Balboa Park Central Mesa

Precise Plan

Proposed Amendment for
Plaza de Panama, Circulation, and a Parking Structure

April 5, 2012
Sixth Draft

8. The Mall

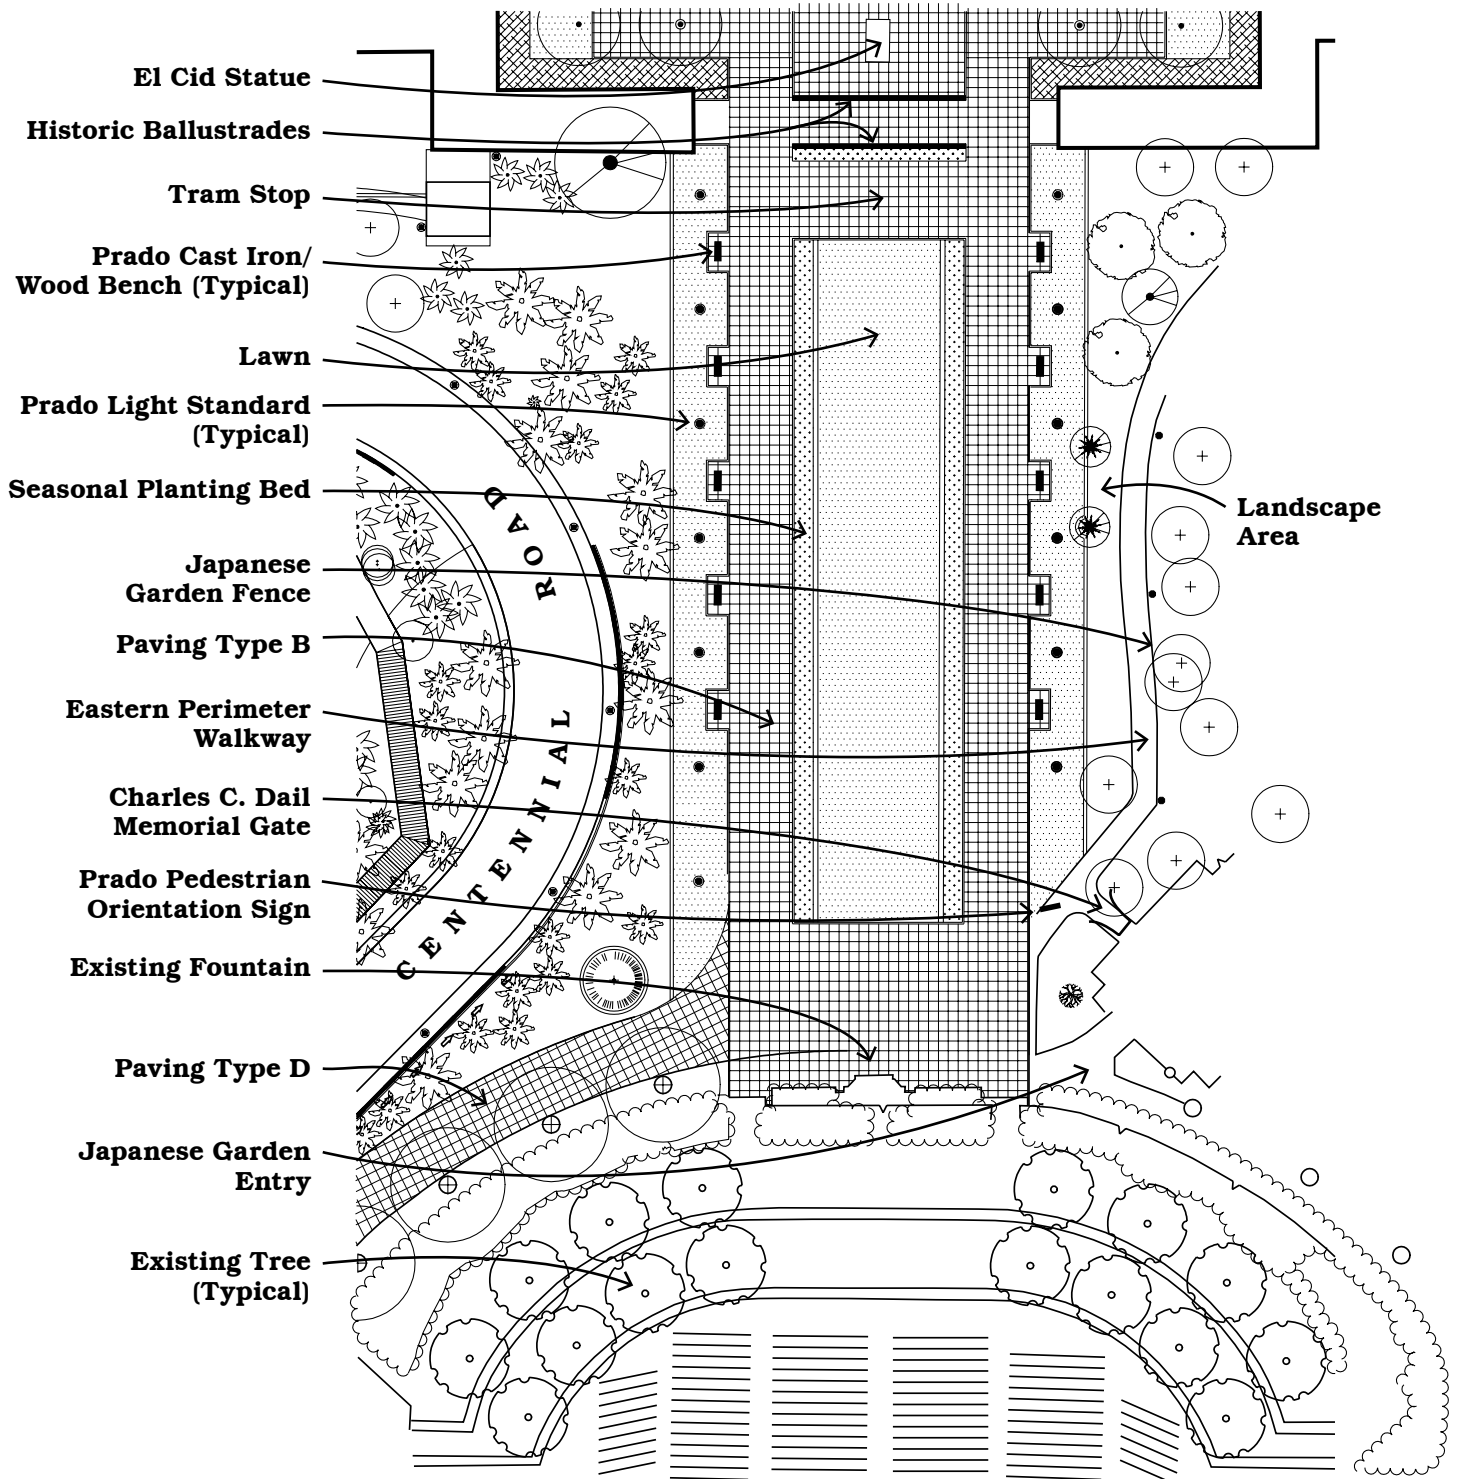
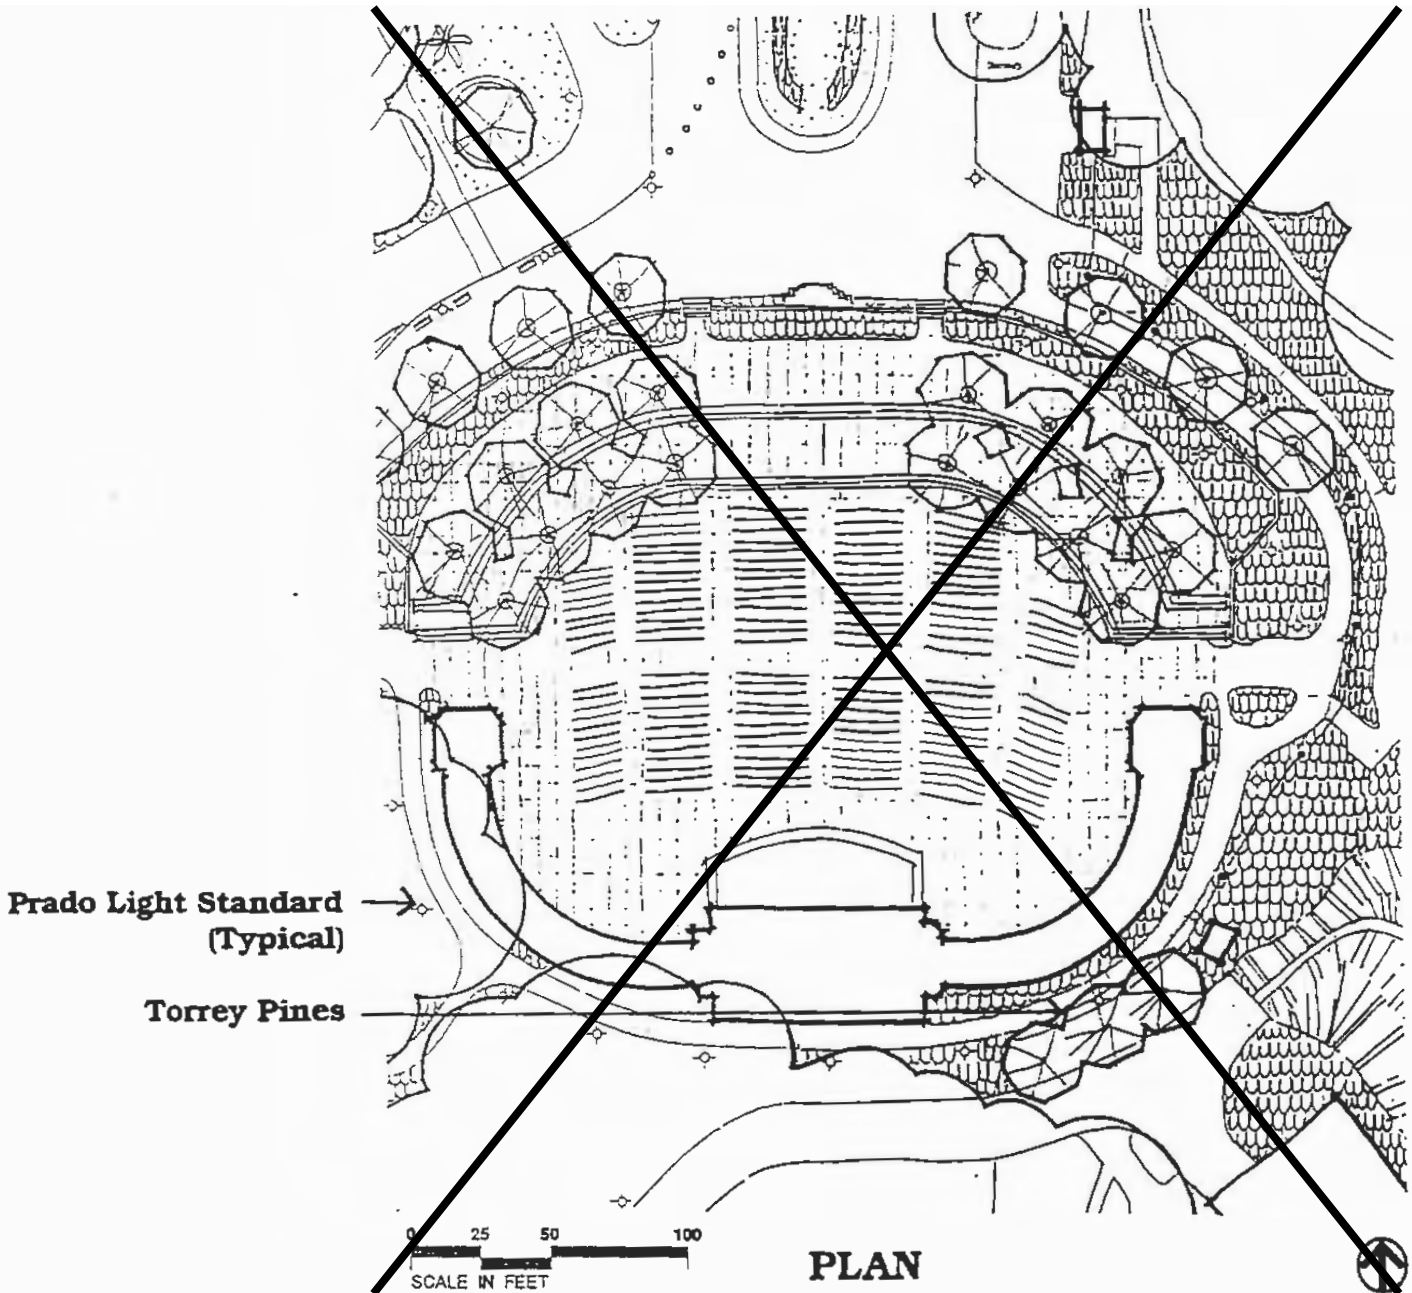
- ~~Retain the existing configuration of the central landscaped area containing lawn and seasonal planting beds.~~
- ~~Border the planting area with a six foot wide type C concrete sidewalk separated from adjacent paving by a six inch curb.~~

- Restore the central landscaped area to its original 1915 proportions.
- Relocate the existing backflow preventer device located in the central landscaped area to a location hidden from public view.

- ~~Separate automobile circulation from pedestrian areas south of the central planting area with bollards that match the Prado light standard bases.~~

- Relocate existing Queen Palms to other locations in the Park to provide an unobstructed view of the Organ Pavilion from the Plaza de Panama and reintroduce a row of Mall-specific deciduous trees along the east and west edges of the space to emphasize the Mall as an important physical and visual axis between the Organ Pavilion and the Plaza de Panama.
